Interactive comment on “Modelling 3D permeability distribution in alluvial fans using facies architecture and geophysical acquisitions” by Lin Zhu et al.

Received and published: 8 October 2016

Fig. 4. Inversed resistivity and corresponding stratigraphy in Zone 1

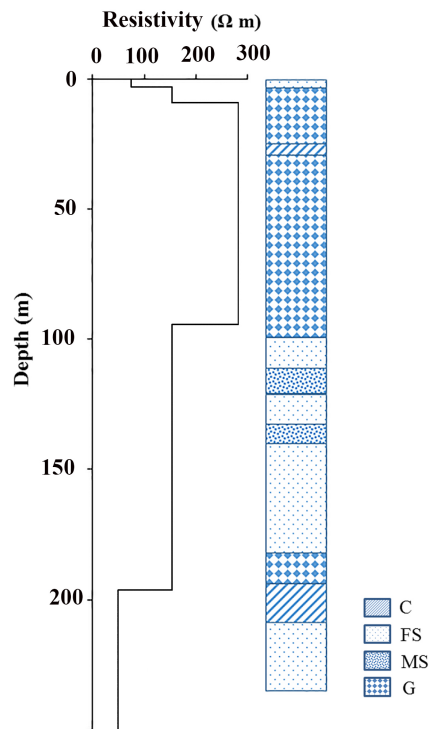
Comment 7: It is unclear how the vertical electric soundings were used, or what these data look like or what they show. This should be clarified.

Response: We added Figure 4 to show the inverted resistivity from VES compared with the lithologic data.

Fig. 6. Experimental (circle symbol) and model (solid line) semivariogram along the dip direction for the various hydrofacies in Zone 2 and Zone 3.

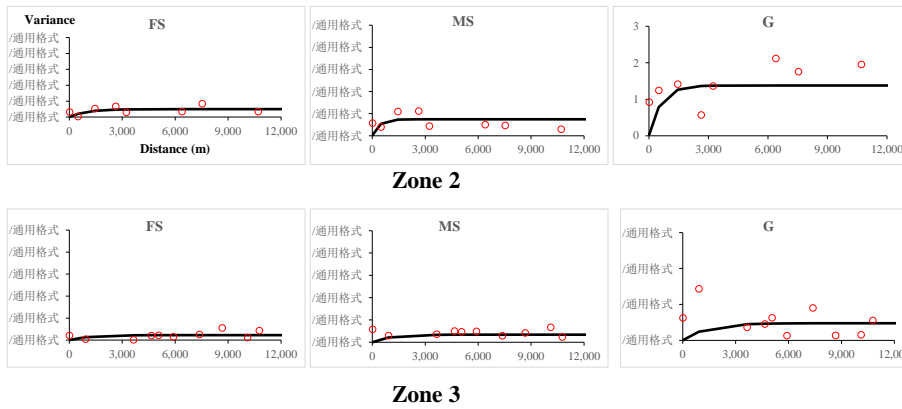
Comment 5: Additionally, your horizontal variograms don't show very much character. The fit is somewhat arbitrary. This is very common since the spacing between wells is often greater than the average widths/lengths of lithofacies, especially since strictly horizontal measures from logs may not indicate the actual paleo horizontal. It's fine to show these models, but how sensitive were the results to these variograms (probably not very sensitive, but maybe).

Response: Yes, the horizontal variograms are fitted with some degree of arbitrary due to the sparse horizontal samplings or larger well distances. By using the variances

estimated from the inversions of vertical variograms as prior information, the estimated variances and ranges of log₁₀(K) in horizontal direction are reasonably constrained. We added a few sentences to discuss the uncertainty of the estimated horizontal ranges.

Fig. 8. Distribution of hydrofacies (after Zhu et al., 2015a) and $\log_{10}(K)$ in the three-dimensional domain representing the Chaobai alluvial fan: (a) axonometric projection of the three-dimensional system and

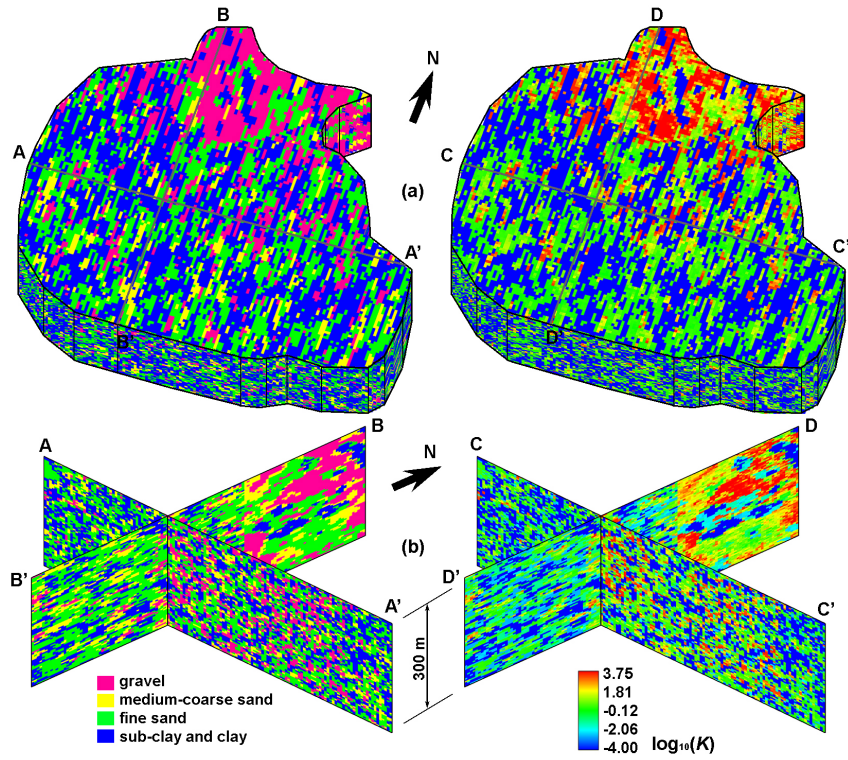
Comment 4: It isn't entirely clear how the lithofacies were placed into the variograms or modeled. Were lithofacies distributions modeled first, then variability added using variograms? Or, were K values assigned to the various lithofacies observed in well logs and lithologic logs, and then the variograms created from these K values? This must be clarified so others can apply your techniques. Looking at Figure 7, it appears as if you modeled lithofacies distributions first. . . .how did you do this?

Comment 6: Figure 7 indicates that the facies were modeled with dip direction in one orientation, thus facies near the apex area will not include a radiating pattern that emanates from the fan apex. This should be noted somewhere. Also, the authors could note that a priori orientation information from surface mapping of the fans could be used to create a model with channel orientations aimed at the apex (See work by Carle et al., where they are able to put varying orientations into the resulting models). Response: In the description of Figure 7 (new Figure 8), we added a sentence to indicate that “since we simulate the dip direction along one orientation (along the main water flow direction), the simulated facies in the fan apex do not show a radiating pattern. More information about simulating the radiating pattern can be found from Carle and Fogg (1997) and Fogg et al. (1998)”.

Response: Yes, the lithofacies distribution was modeled first. Then, the distributions of $\log_{10}(K)$ for three facies including G, MS, and FS were simulated, respectively, using SGSIM with the parameter determined from individual semivariograms. The 3D cells of the distributions of $\log_{10}(K)$ is the same as that of the lithofacies indicator model. And then, since each cell is characterized by specific facies indicator and zone indices, its conductivity was assigned or mapped based on the corresponding facies, zone numbers and the 3D SGSIM simulated conductivity values. Finally, since sub-clay and clay are generally characterized by a low hydraulic conductivity value, a uniform conductivity value equal to 0.0001 m/d was set to all the C cells (new Line 244-247). The procedure flowchart is already provided in Figure 2.
